Commonwealth of Pennsylvania  
Environmental Resources  
May 11, 1983

**Subject:** Advisory Notice  
Research on Operation of  
Pressure Distribution Systems with  
Pump and Siphons

**To:** SEWAGE ENFORCEMENT OFFICERS  
COUNTY HEALTH DEPARTMENTS

## INSTALLATION OF LATERAL CLEANOUT

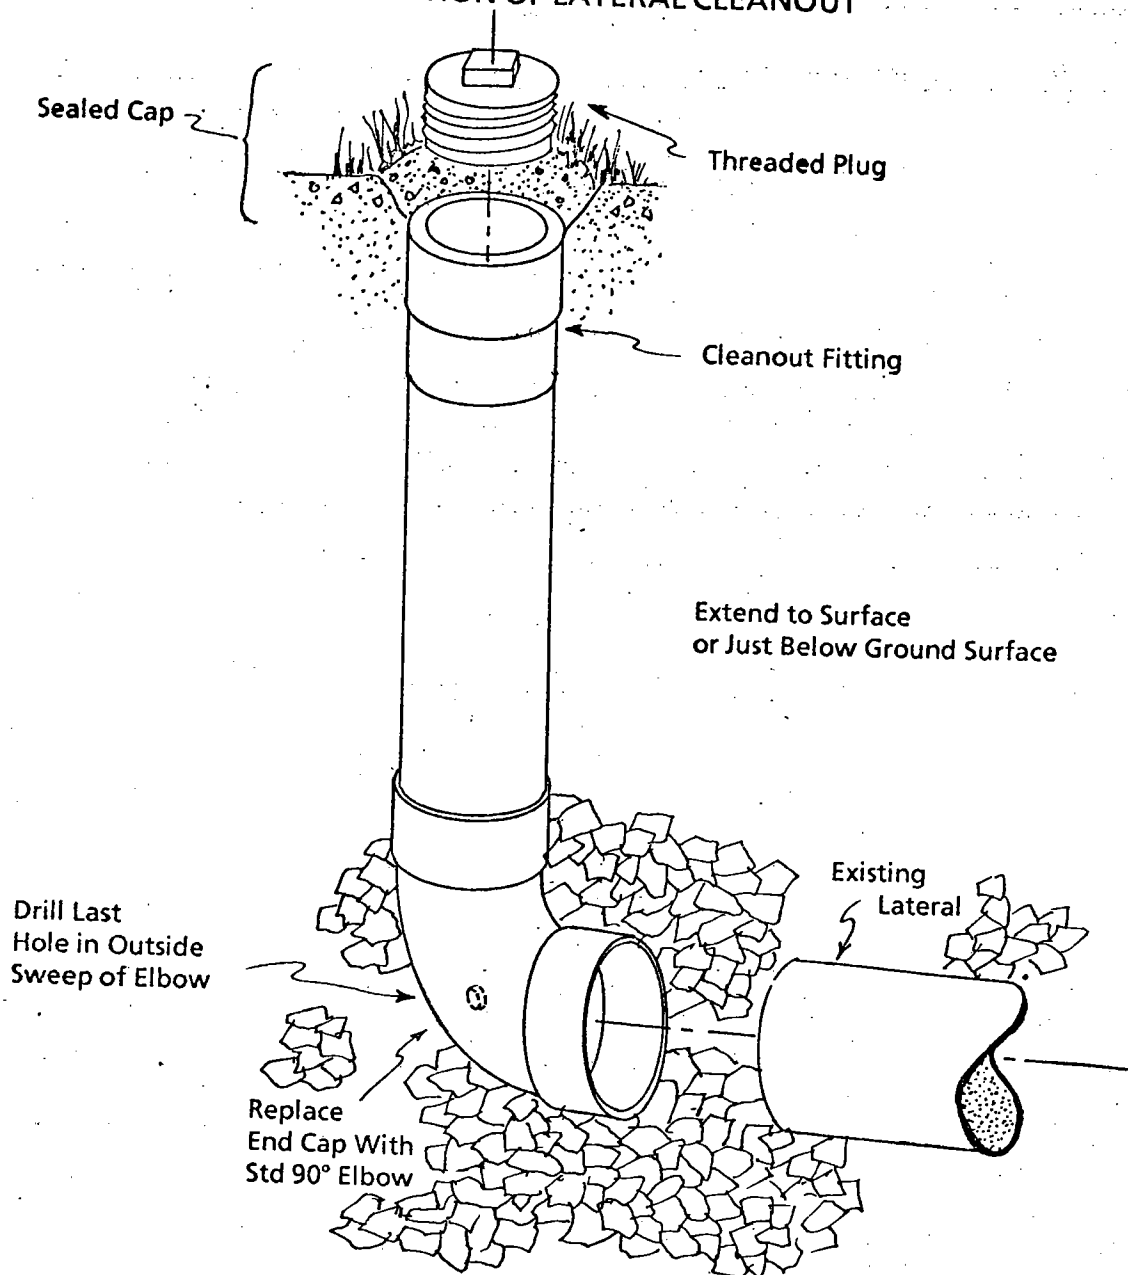
1. Determine if the siphon bell and dosing tank are level. If necessary, relevel the siphon bell or relevel the entire tank to establish proper siphon action.
2. Remove the lateral end caps and flush the system several times with fresh water. Replace the system end caps (installation of cleanout ports, a diagram of which is attached to this notice, may be substituted for the end caps where the effluent quality is extremely poor or foreign objects are found in the pipes, and repeated clogging is possible).
3. If the effluent quality is still poor, recommend to the applicant/permittee that the septic tank be pumped annually, and/or septic solids retaining devices; or where feasible, multiple septic tanks be installed.

All PVC Piping  
1 1/2" Diameter

figure IX-21

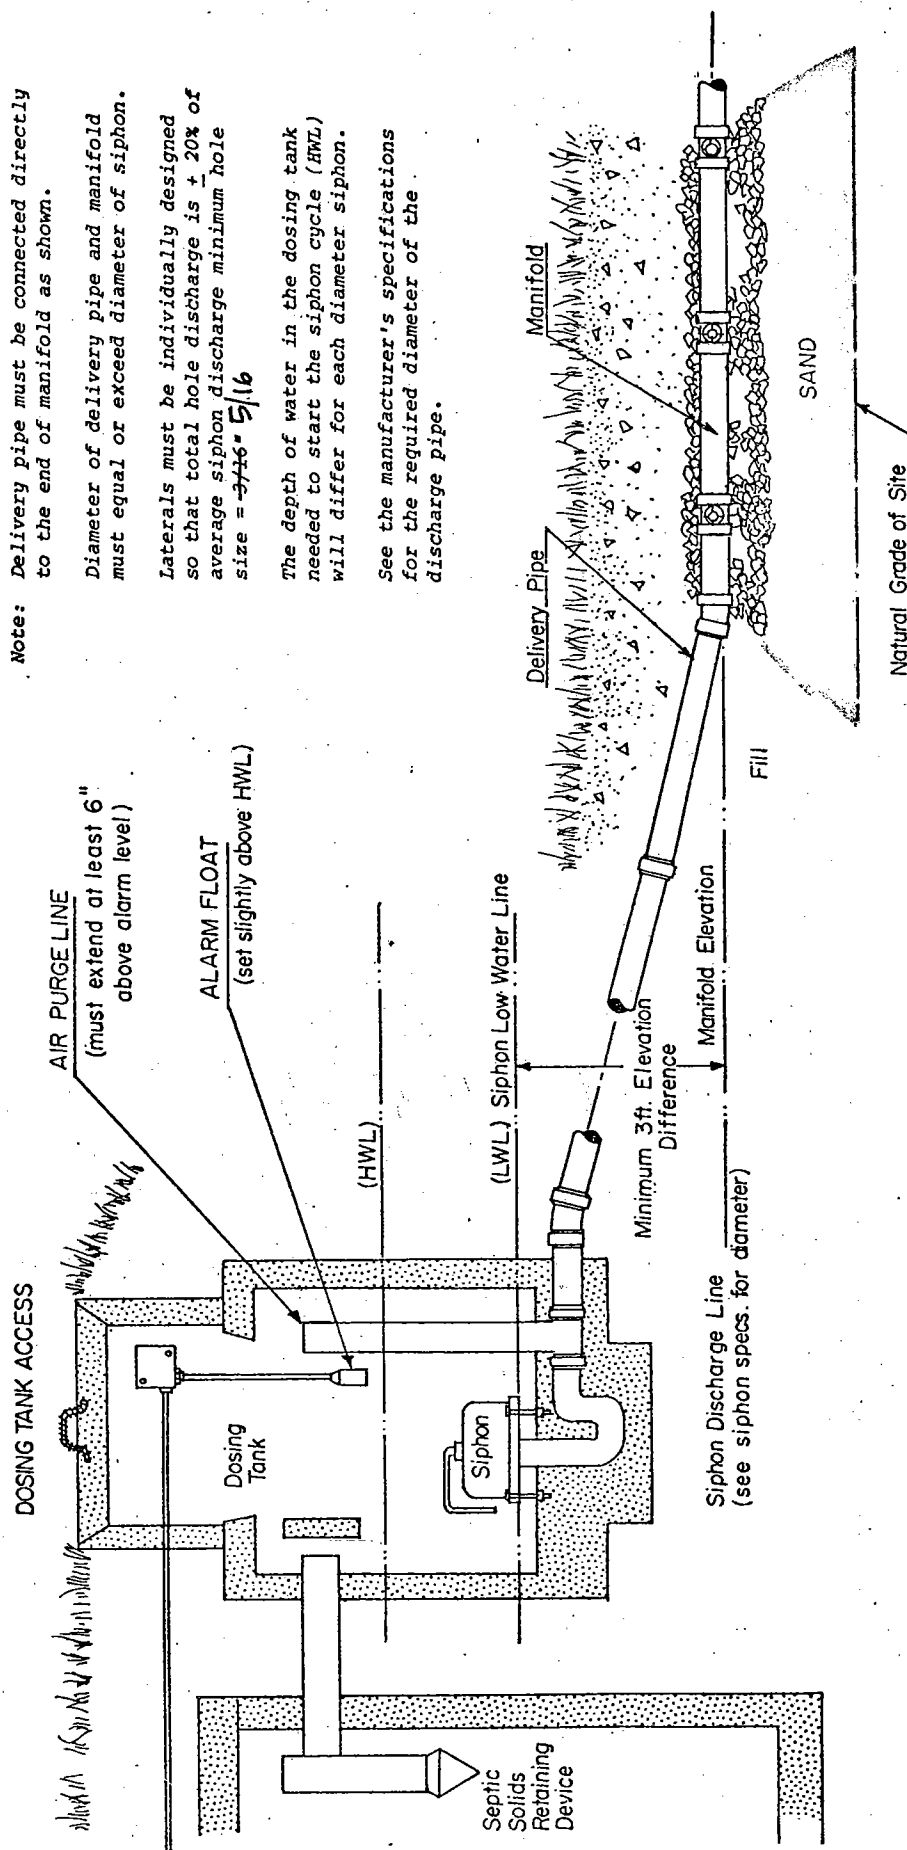
A revised diagram of a typical siphon installation is attached to this notice, and should be inserted in your copy of the SEO Manual to replace the existing diagram on page IX-26.

**Note:** Delivery pipe must be connected directly to the end of manifold as shown.

Diameter of delivery pipe and manifold must equal or exceed diameter of siphon.

Laterals must be individually designed so that total hole discharge is  $\pm 20\%$  of average siphon discharge minimum hole size =  $3/16" \times 5/16"$
